TEMPORARY LODGING FACILITY (TLF)  
LITTLE ROCK AIR FORCE BASE

LANDSCAPE PLAN  
AS-BUILT

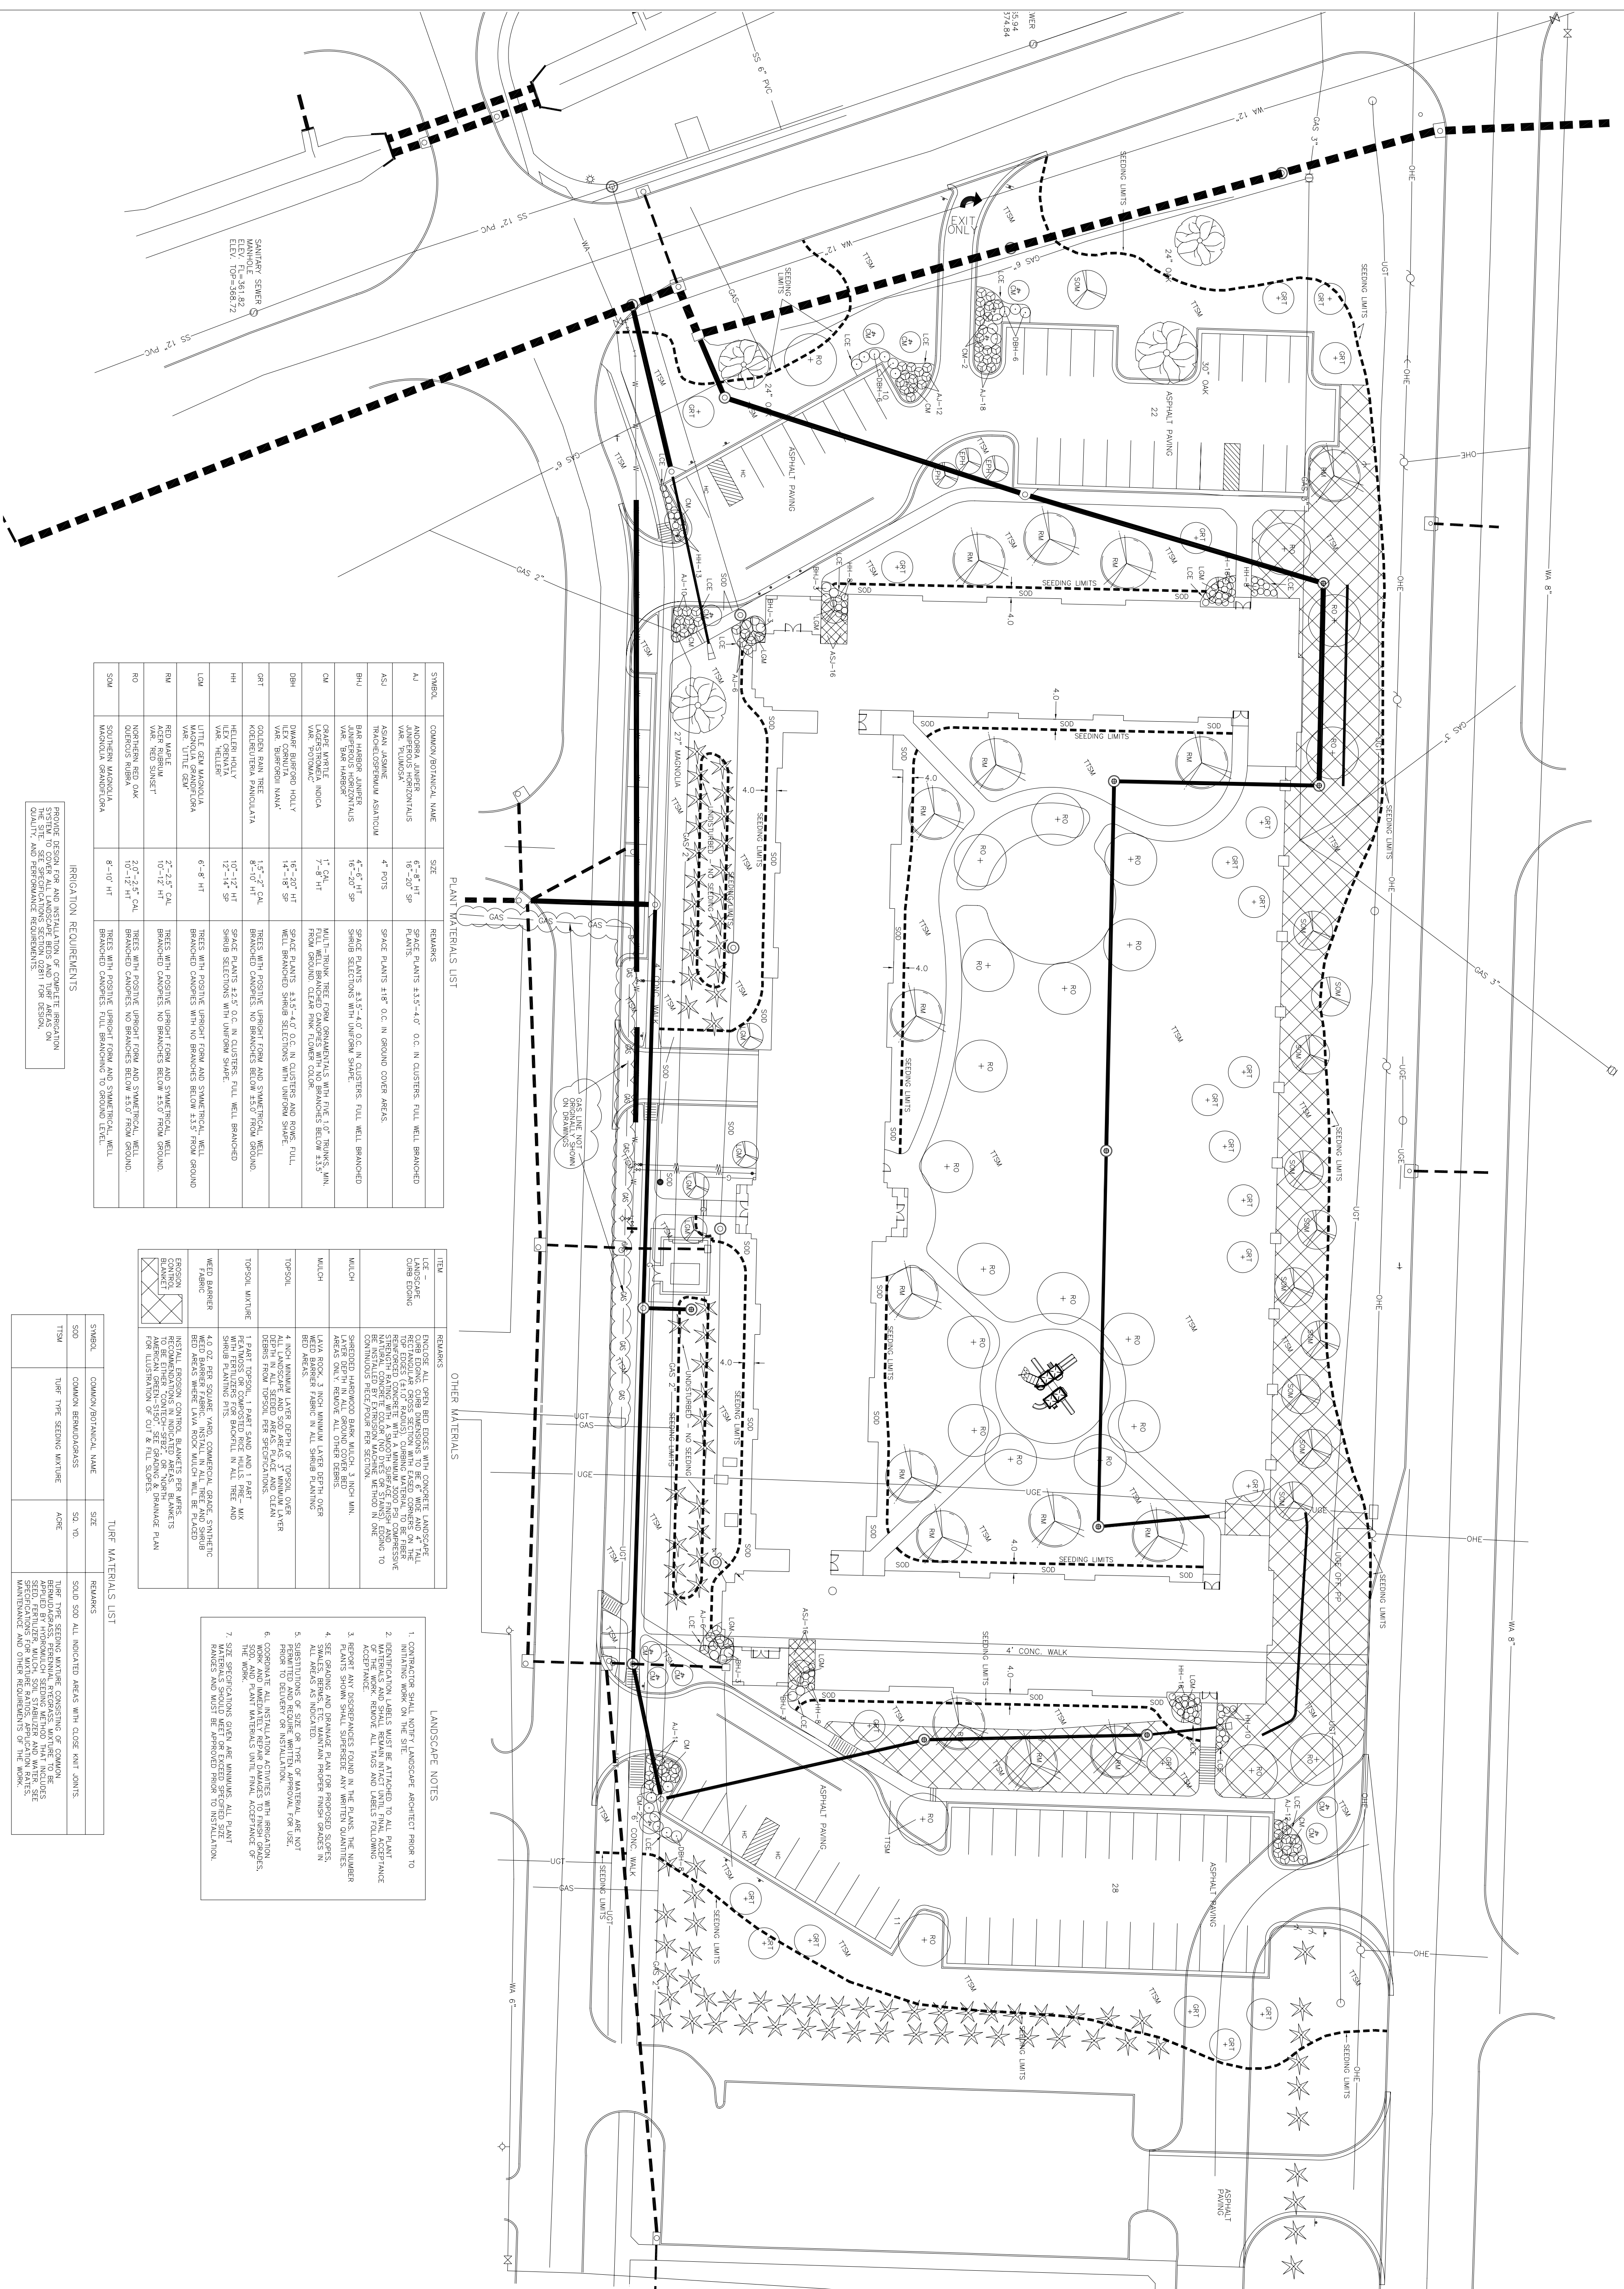
1	Added Gas Line as shown not originally shown on drawings			
No.	Revision/Issue	Date	BY	APP'D
